Work Order ID 86954

Item ID: D212-664-107 Accept ***N900040100*** Setup Start ***NS1***
 Revision ID: Stop ***NS2***
 Item Name: Crosstube Low Standard Fwd
 Start Date: 7/06/12 Start Qty: 1.00 ***1*** Cust Item ID:
 Required Date: 8/10/12 Req'd Qty: 1.00 ***1*** Customer:
 Reference:

DRAWING NO. D212-664-147	TITLE CROSSTUBE ASS'Y (205 LOW FWD)	REV. B	DART AEROSPACE LTD ENGINEERING ORDER		D.E.O. NO. D212-664-147-B-1	SHEET NO. SHEET 1 OF 1	SCALE NTS
DRAWN <i>Q</i>	CHECKED <i>ASS</i>	MFG. APPR. <i>VB</i>	APPROVED <i>MP</i>		DE APPR. <i>MP</i>		
DATE 11.07.15	DATE 11.07.20	DATE 11.07.21	DATE 11/07/21		DATE 11.07.21

REPLACE MAGNOBOND WITH PROSEAL.

**D212-664-147/-147B
ASSEMBLY DETAIL**

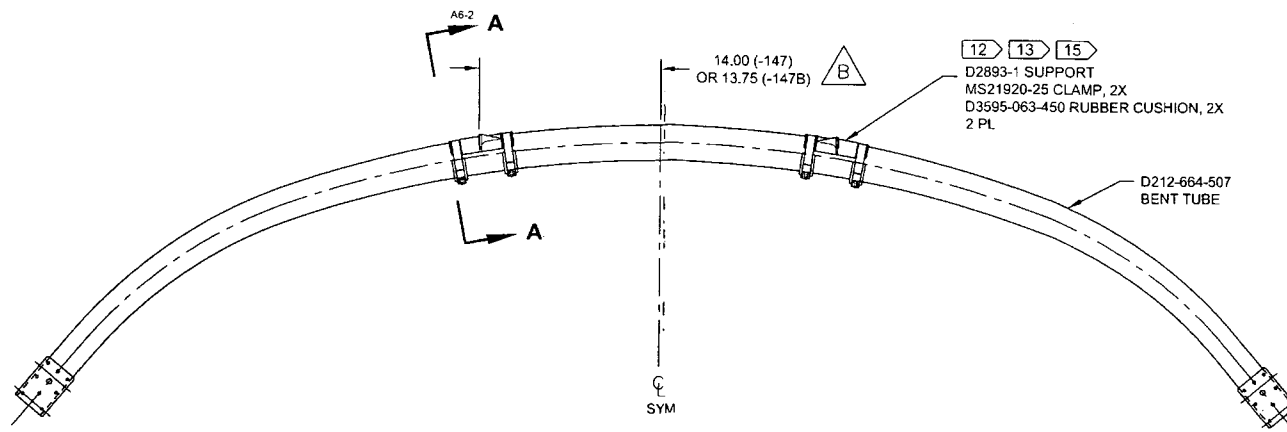
NOTE 12 & 15, SHEET 1 IS AMENDED AS FOLLOWS:

Item	Qty -147	Qty -147B	Part Number	Description
9	A/R	A/R	PROSEAL 890 B-2	SEALANT, AMS-S-8802 CLASS B-2

- 12) TO INSTALL D2893-1 SUPPORT: ABRASE MATING SURFACE OF SUPPORT AND CROSSTUBE WITH 180-GRIT SANDPAPER AND REMOVE RESIDUE WITH MEK (OR EQUIVALENT). APPLY A 0.04" TO 0.07" THICK LAYER OF PROSEAL 890 CLASS B-2 (OR AMS-S-8802 CLASS B-2) SEALANT TO MATING SURFACE OF SUPPORT.
- 15) TORQUE CLAMPS 80 TO 100 IN-LB. ENSURE AT LEAST 1.5 THREADS SHOWING IN SAFETY AND THAT NUT HAS NOT BOTTOMED-OUT AFTER TORQUING. **PRIOR TO PACKAGING, RE-CHECK TORQUE ON CLAMPS AFTER PROSEAL 890 SEALANT HAS CURED FOR 72 HOURS.**
